PLANNING COMMITTEE MEETING No. 226

**Thursday 23 July 2026
6pm**

On balance and having considered all the relevant matters within the Planning Scheme, it is respectfully recommended that the Council issue a Notice of Decision to Grant a Planning Permit for the Use and Development of a Child Care Centre.

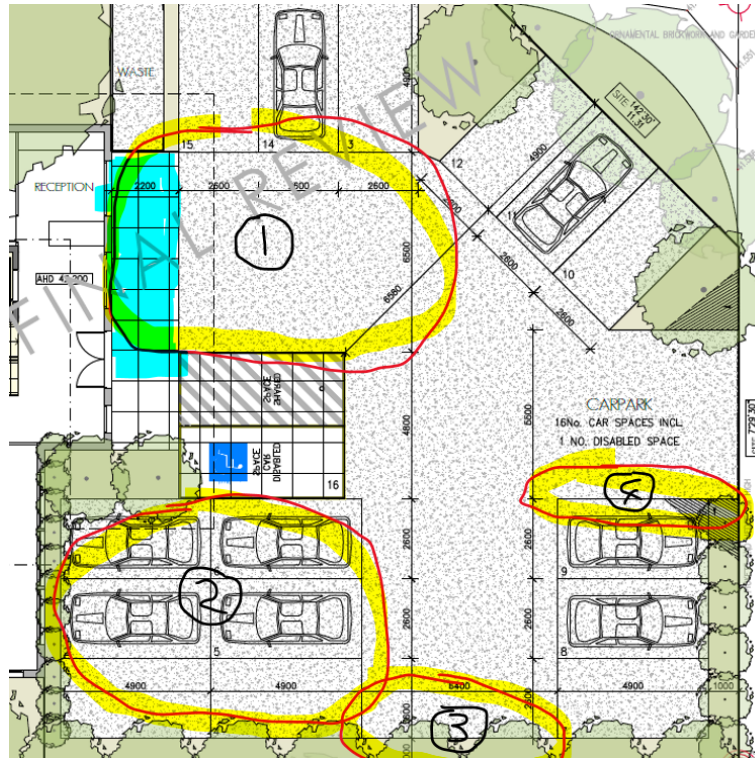
Department:	Civil Infrastructure
Response:	1st Engineering Response Parking Demand & Supply The proposed child care centre is proposed with 78 child places (<i>*it is noted this was later changed to 72 children</i>). (78 children) has a statutory parking demand of 17 spaces. ($78 \times 0.22 = 17.16$). The proposed car park has a supply of 16 car spaces (subject to design issues), which is a shortfall of one car space. Parking waivers for child care centres are not supported, and in this case will not be supported. If 78 child places are proposed, then 17 car spaces must be provided on-site. Car Park Design It is noted that a Traffic Impact Assessment has not been provided with the application to justify the car park design. The design of the car park is of an unacceptable standard for a child care centre, The main issues are: 1. Car spaces 13, 14 & 15 rely on a blind aisle extending into the footpath that is apparent between the building and parking aisle in an area where the main entry to the building is located and where pedestrian movements will be prevalent. 2. For the scale of this development and of the car park, tandem parking is not supported. 3. A blind aisle is not provided for the southern car spaces.

4. A landscaped island has not been provided to separate the driveway and the adjacent car space.

Design Options

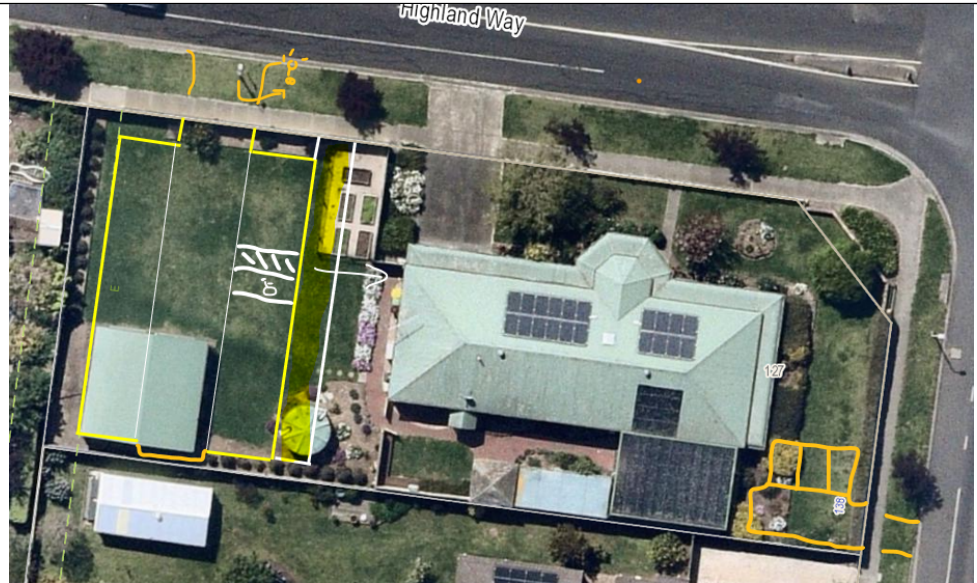
The lot is about 25 m wide and is a corner lot. There should be opportunity to re-design the child care centre so that a conventional car park with two rows of parking on each side of the parking aisle in the western part of the lot with access from Highland Way (see sketch overleaf).

- There is a light pole in Highland Way that will require relocation to allow for the vehicle crossing.
- There must be a footpath between the eastern row of car spaces and the building.
